ADDENDUM NO. 4

REQUEST FOR QUOTATIONS (RFQ) NO.: 1220-040-2016-041

TITLE: NEWTON CULTURAL CENTRE
ROOF REPLACEMENT

ADDENDUM ISSUE DATE: MAY 30, 2016

TITLE: ROOF PLAN	
CLIENT: CITY OF SURREY	
PROJECT: NEWTON CULTURAL CENTRE 13520 72 AVE SURREY, BC	
IRC #:	18100
W.O.#:	VR16-046SP
SCALE:	1"=10'
DATE:	MAY 27/16
DRN. BY:	B.W.
CHK. BY:	D.W.
NORTH:	
DWG.#:	
R1(REV.1)

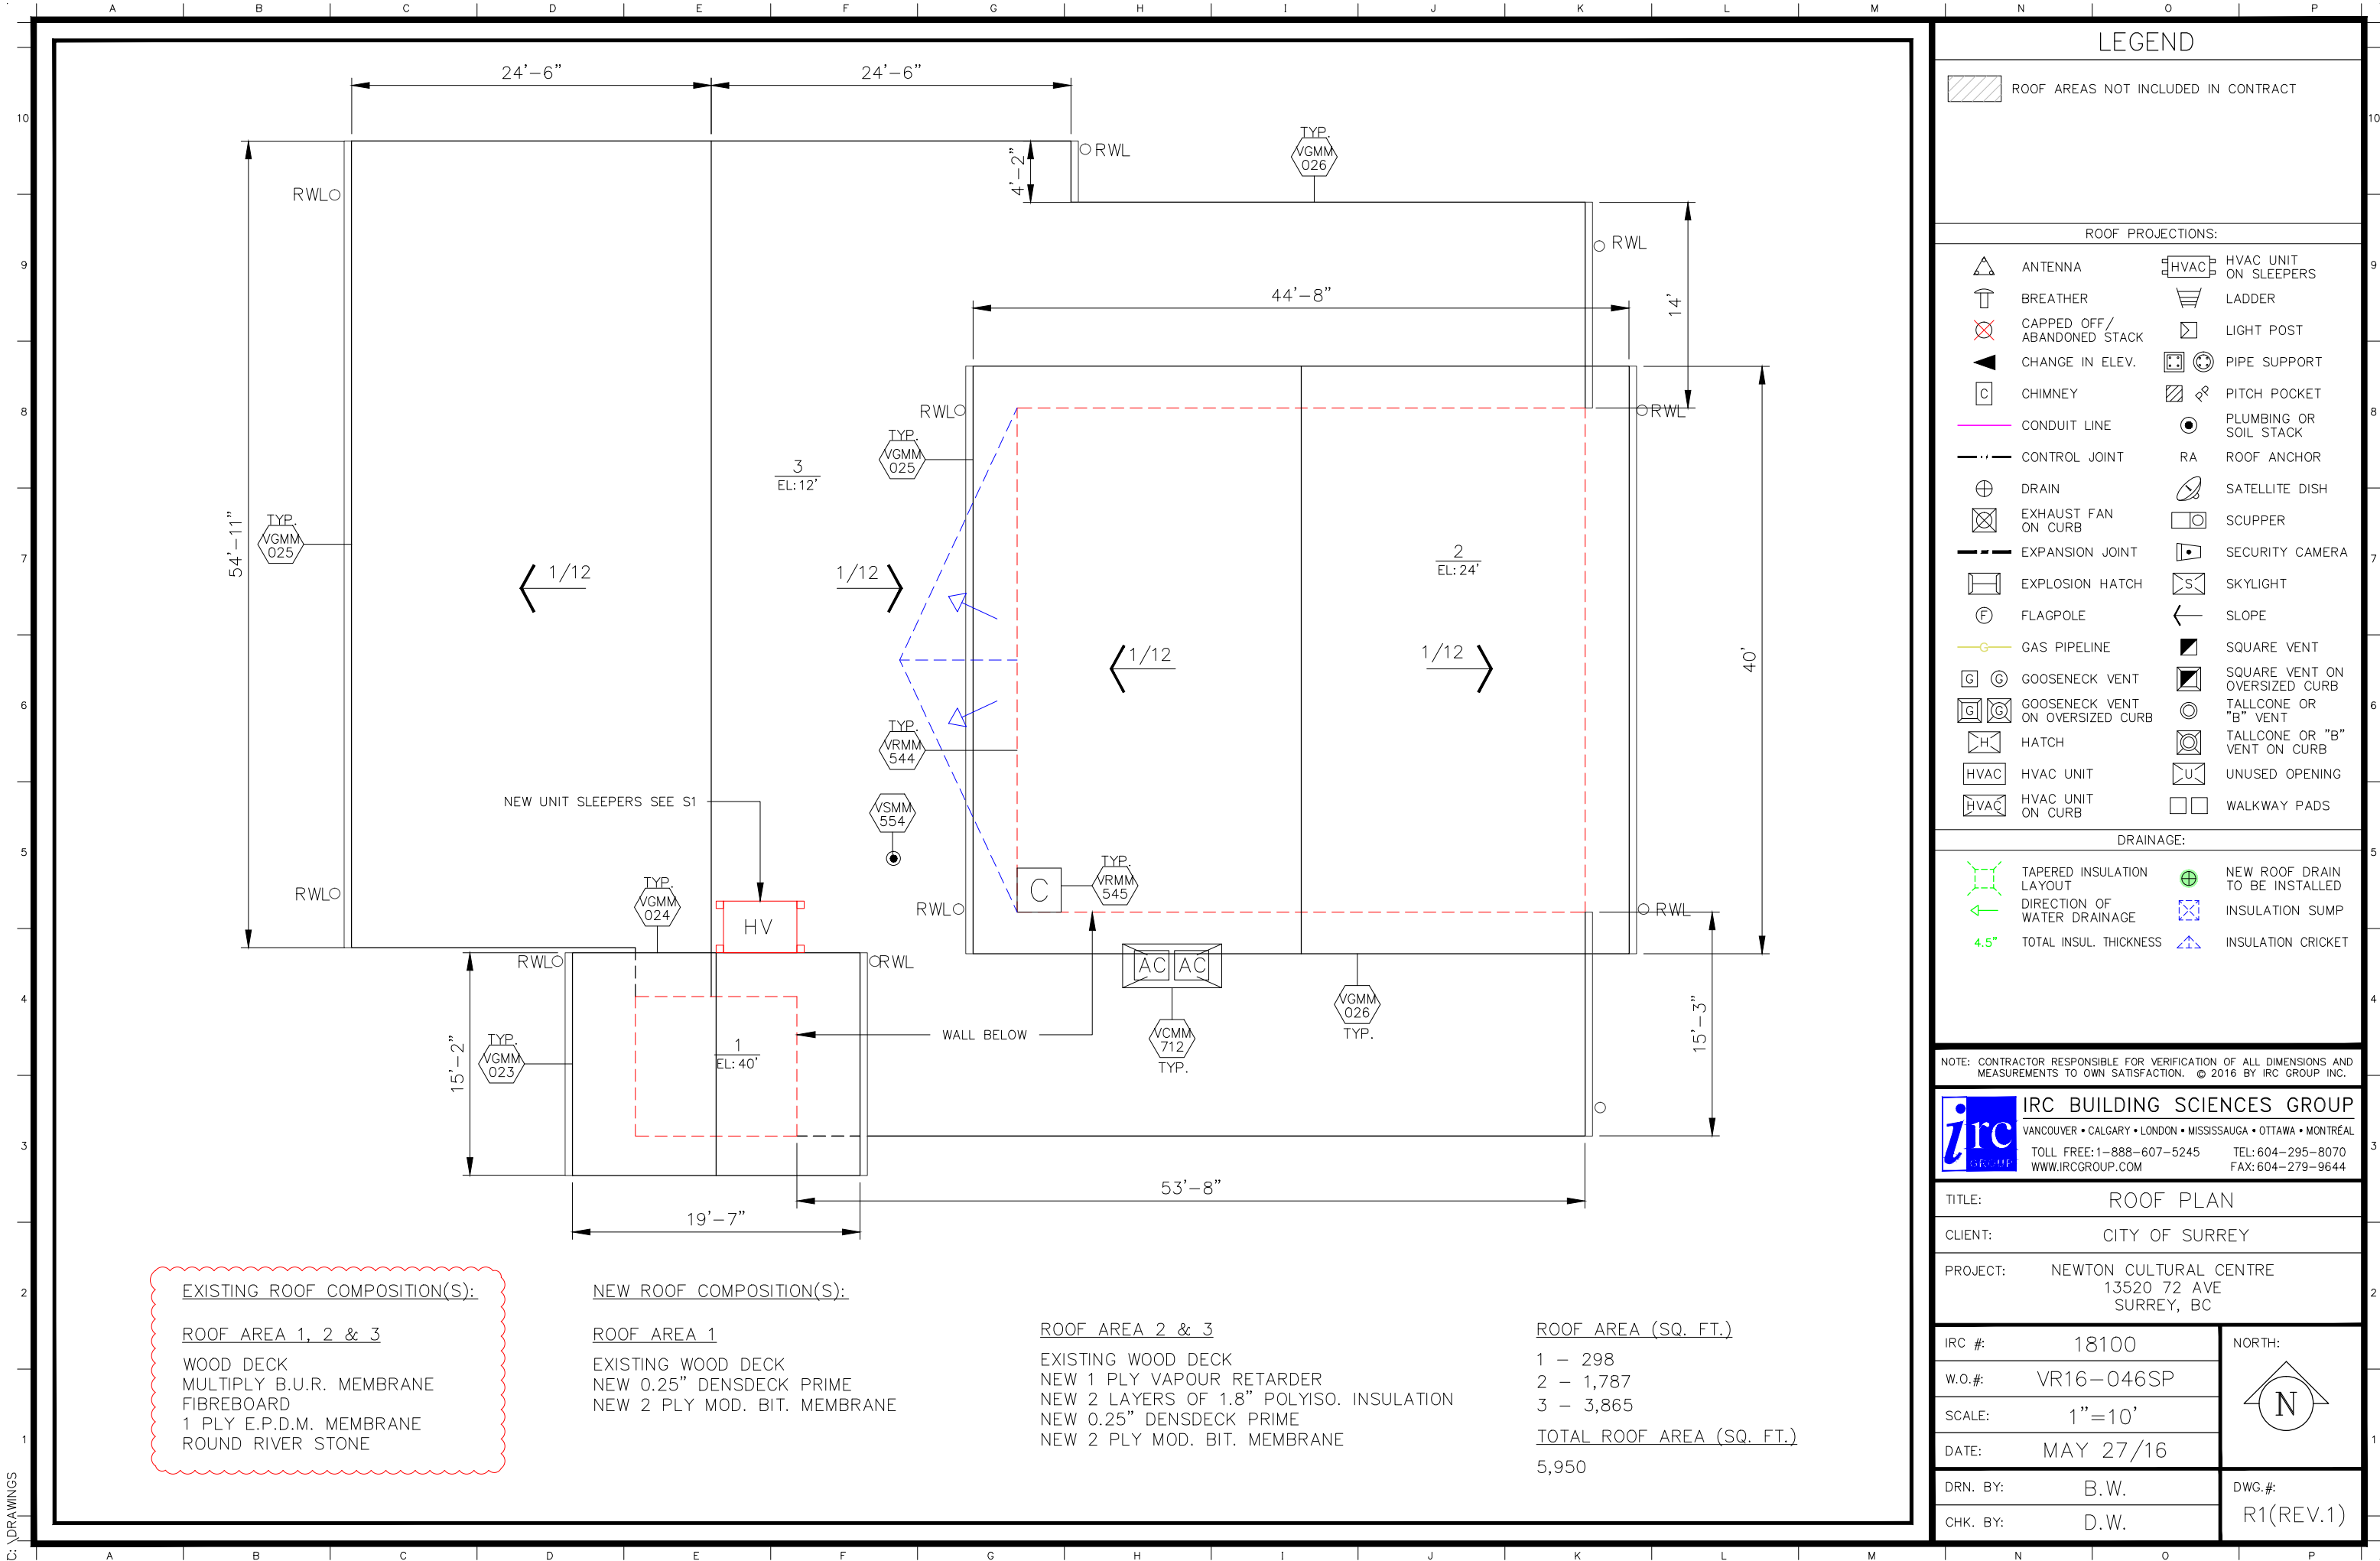
There exists a discrepancy between the specification and drawings. To further clarity for the bidders, a revised roof plan is attached with corrected verbiage to match Section. Further, the system description within the Specification has allowed misunderstanding resulting in the following changes:
